SIL 4-WT-17, Rev. A
June 04, 2021
Page 1 of 4

SUBJECT: New Transmission Breather

MODELS AFFECTED: All 3000, 4000, T and B Models Transmissions

Figure 1. Former and Current Breathers

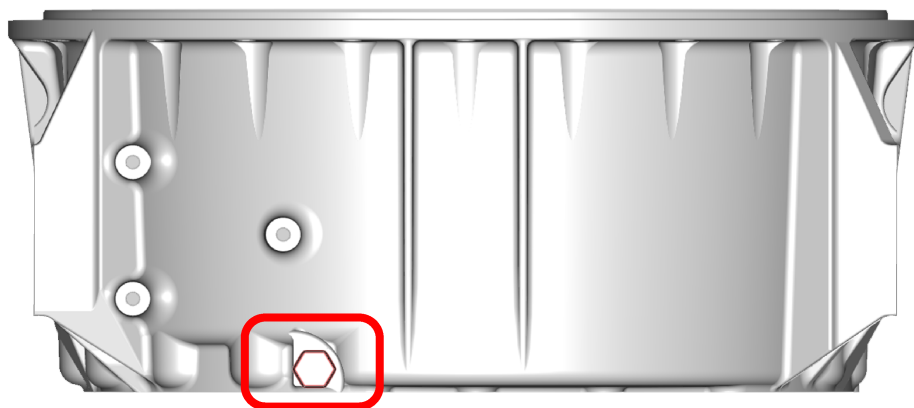
Effective February 2017, Allison Transmission, Inc. has introduced a new transmission breather.

The new breather incorporates an outer hex design that simplifies installation and removal. The hex fits a 23-mm socket or end wrench. Installation torque remains unchanged at 12-16 N·m (9-12 lb ft). No orientation of the hex is required. The new breather is backwards compatible in transmissions assembled after December 2014. Refer to [Table 1](#) for breather details.

Part Name	Former Part Number	Current Part number
Breather	29551584	29558351

Figure 2. Location of Breather (Standard Converter Housings)

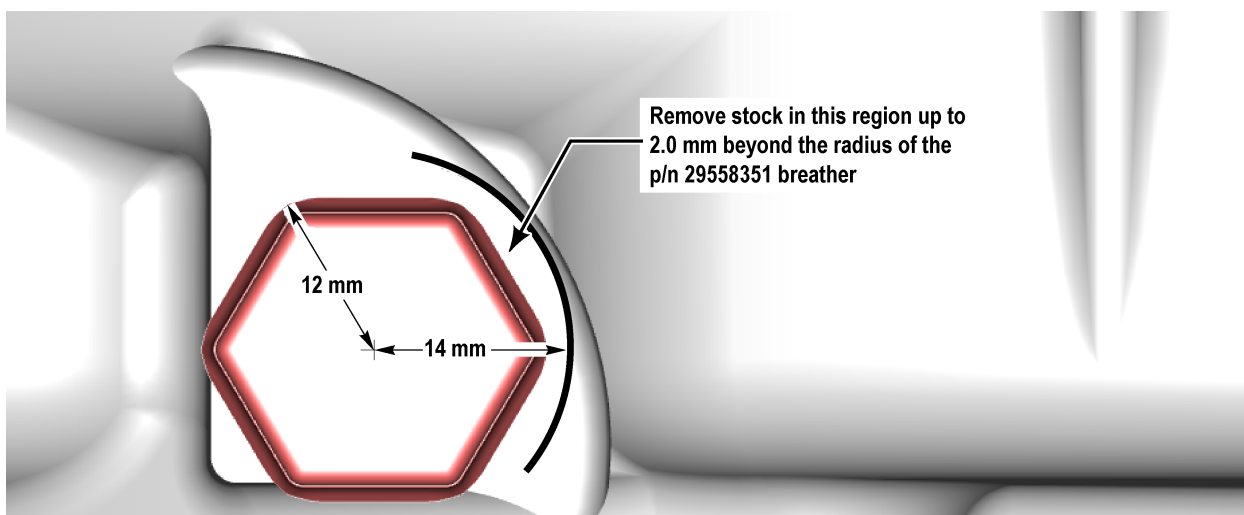
In 4000 and B500 Series transmissions with Standard Converter Housings manufactured prior to December 2014, interference between the breather and aluminum housing can occur. The interfering material may be safely removed from the aluminum housing by removing stock up to 2.0 mm beyond the radius of the P/N 29558351 Breather as shown in Figure 2, Figure 3, and Figure 4. Take care to remove no more stock than necessary to prevent breaking through the cast wall. Prior to removing stock, seal the tapped breather hole to prevent entry of contamination.
